Access Compliance Report

Public Rights-of-Way

(Curb Ramps)

Intersection ID: 30465	Main Street: PLANTERS_ROW_DR	Cross Street: GOLDEN_VIEW_DR	Location: S
ADA ID: E50D4DBEA6AD	Ramp Type: Directional1	Initial Pass/Fail: Fail	Overall Compliance: No
		Severity Score: 25

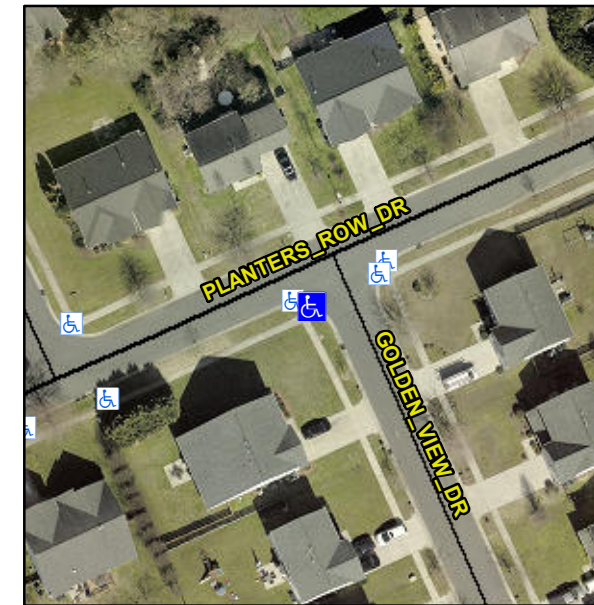
R304.5.3

Compliance	Description	Data	Compliance	Description	Data
N/A	Ramp Length (in)	36.0	N/A	Grade Break?	N/A
Yes	Ramp Width (in)	64.0	N/A	Grade Break Slope (%)	0.0
Yes	Ramp Slope (%)	2.2	N/A	Grade Break XSlope (%)	0.0
No	Ramp XSlope (%)	8.8			
N/A	Flare Type LT	N/A	N/A	Flare Type RT	N/A
N/A	Flare Slope LT (%)	N/A	N/A	Flare Slope RT (%)	0.0
N/A	Flare Traversable LT?	N/A	N/A	Flare Traversable RT?	N/A
N/A	Landing Length (in)	0.0	N/A	DWS Provided?	N/A
N/A	Landing Width (in)	0.0	N/A	DWS Contrast?	N/A
N/A	Landing Slope (%)	0.0	N/A	DWS Length (in)	N/A
N/A	Landing X Slope (%)	0.0	N/A	DWS Full Width?	N/A
N/A	Landing Curb? (Y/N)	N/A	N/A	DWS Offset LT (in)	N/A
N/A	Shared Landing?	N/A	N/A	DWS Offset RT (in)	N/A
N/A	Gutter Ponding?	0.0	N/A	Gutter Slope (%)	N/A
N/A	Gutter Lip Ht (in)	0.0	N/A	Gutter X Slope (%)	N/A
N/A	Painted X Walk1?	No		Road Slope (%)	1.3
	X Walk 1 Direction	To NE		Road X Slope (%)	2.5
	X Walk 1 Width (in)	N/A		Clear Space?	N/A

Remove & Replace Entire Ramp.
